# Architectural Design Competition Report

57-61 Archer Street and 34 Albert Avenue, Chatswood

September 2023

**FIGURE 13 PHOTOMONTAGE**

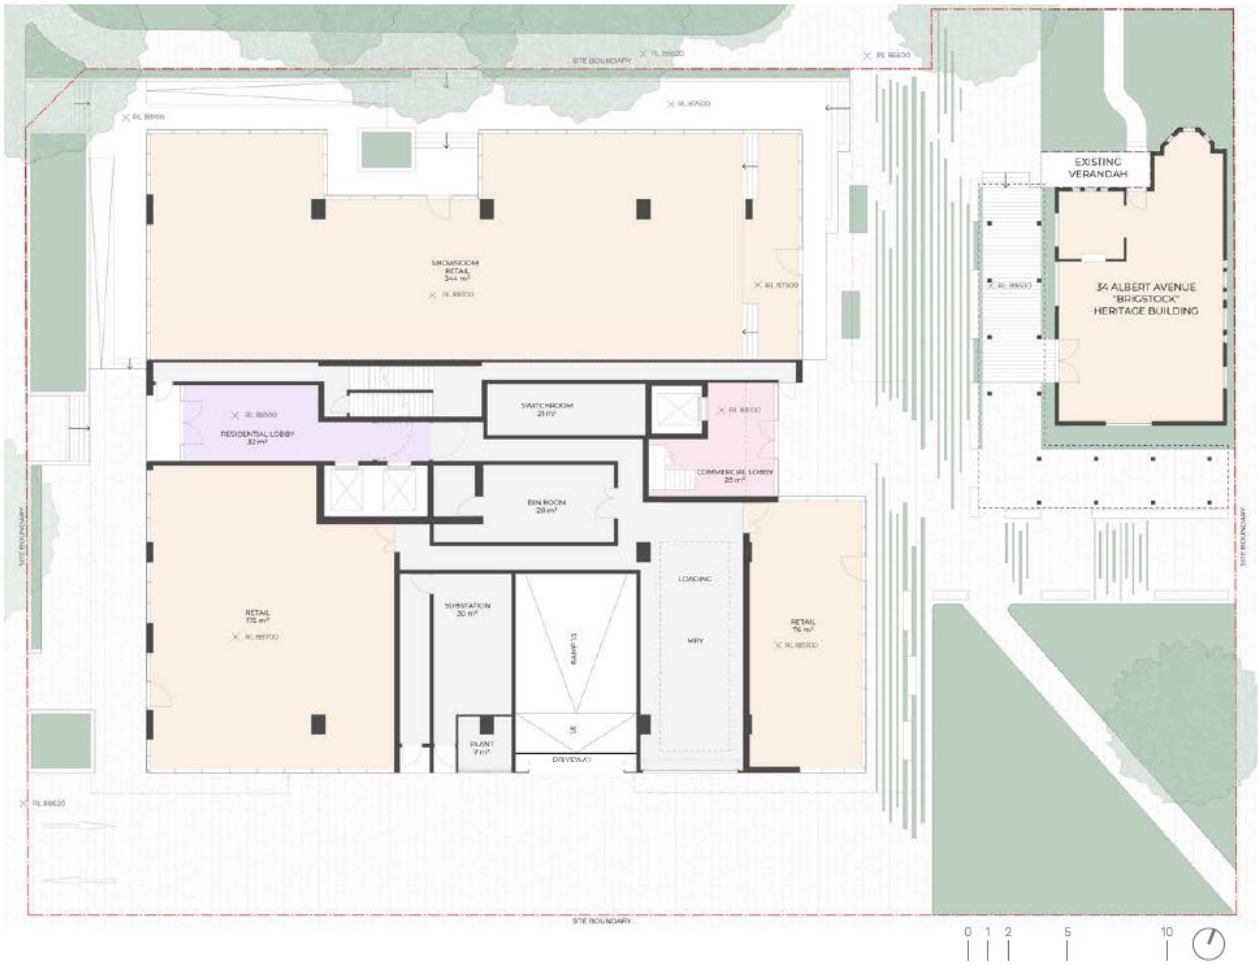
- the clarity and material quality of the continuous concrete horizontal bands and the wrapping of this material to the balcony and terrace soffits to provide visual continuity when viewed from below

- the extent of cantilevered terraces and balconies that bring formal variation and animating shadows to the facade composition and tower silhouette.
- Members of the Jury questioned the finished height of the solid balustrades for the upper level apartments. As part of the design development process, **the design team is encouraged to test and carefully calibrate the proposed balustrade heights (if required) to support improved views without significantly impacting the overall facade strategy and proposed solid to glazed facade ratios.**

- **The design team is encouraged to consider how the environmental responsiveness and performance of the building can be improved by an informed response to each solar aspect that supports the overall architectural facade strategy in a holistic and integrated manner. For example, can discrete sun horizontal or vertical shading elements be incorporated into the window reveals on the western and northern facades without increasing the depth of the facades to augment the use of double-glazing?**

**FIGURE 14 GROUND FLOOR PLAN – PREFERRED OPTION**  
 Source: Woods Bagot

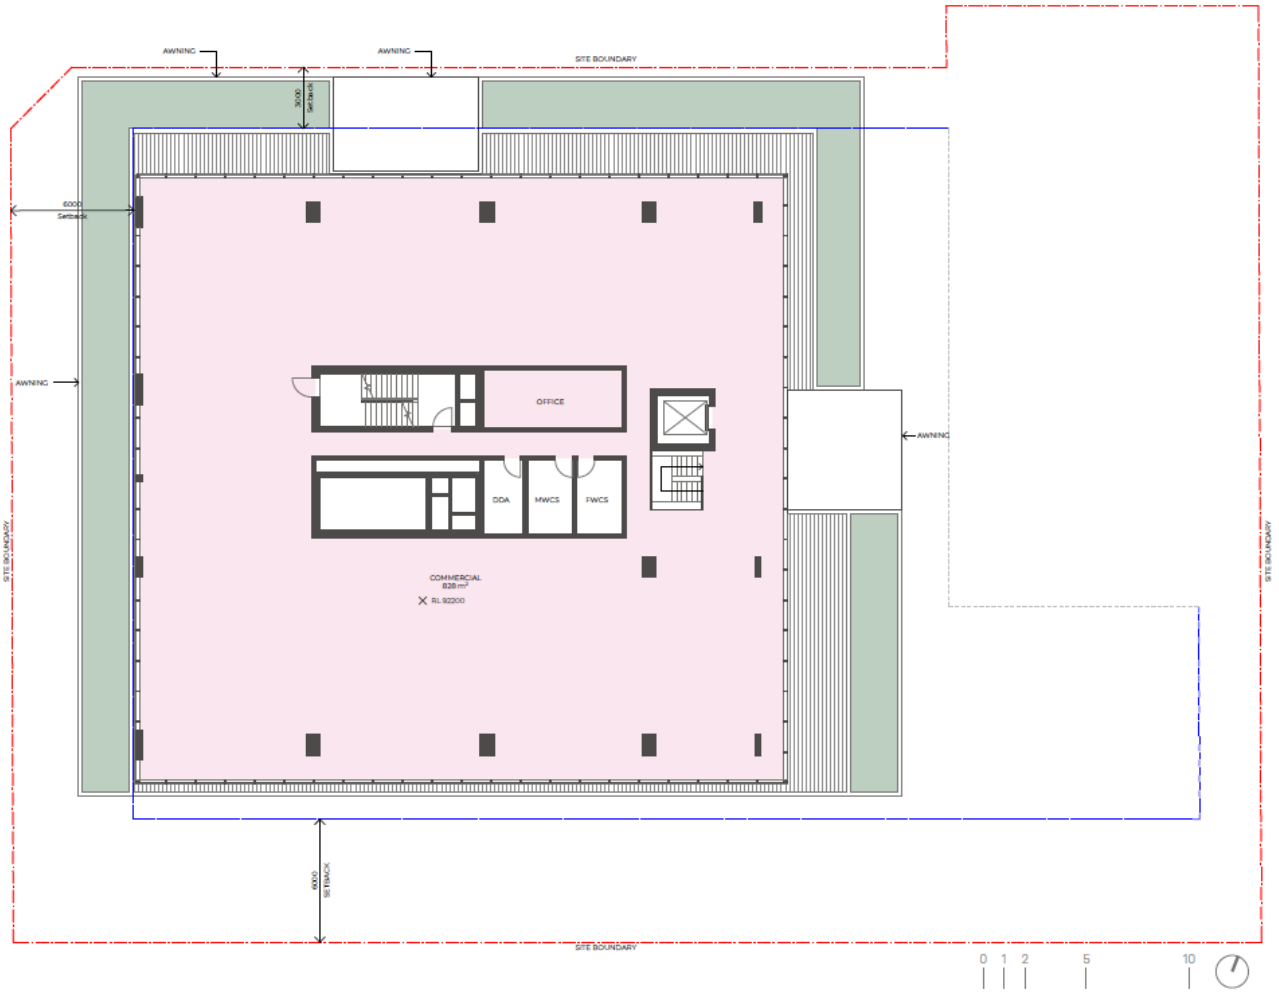
- The Jury supports the location and character of the Archer Street residential address but questioned the size and configuration of the ground floor residential lobby including the lack of BOH areas such as a mail/parcel delivery room. Members of the Jury also questioned whether the lobby should extend through the building as a link. **The design team is encouraged to consider this as part of the wider consideration of the ground floor and basement access/servicing.**

- The Jury questioned the provision of two residential lifts and whether a third lift may be required given the number and size of apartments to be serviced? **Obtain specialist consultant advice to confirm lift requirements.**
- **Ensure there is sufficient rubbish chute provision on each level including recycling with a preference for a dedicated recycling chute rather than a diverter mechanism.**
- The Jury supports the provision of a dedicated commercial lift, stair and lobby and consider them important elements to be retained. **The location of this lobby could be reconsidered as part of the wider ground floor design review.**
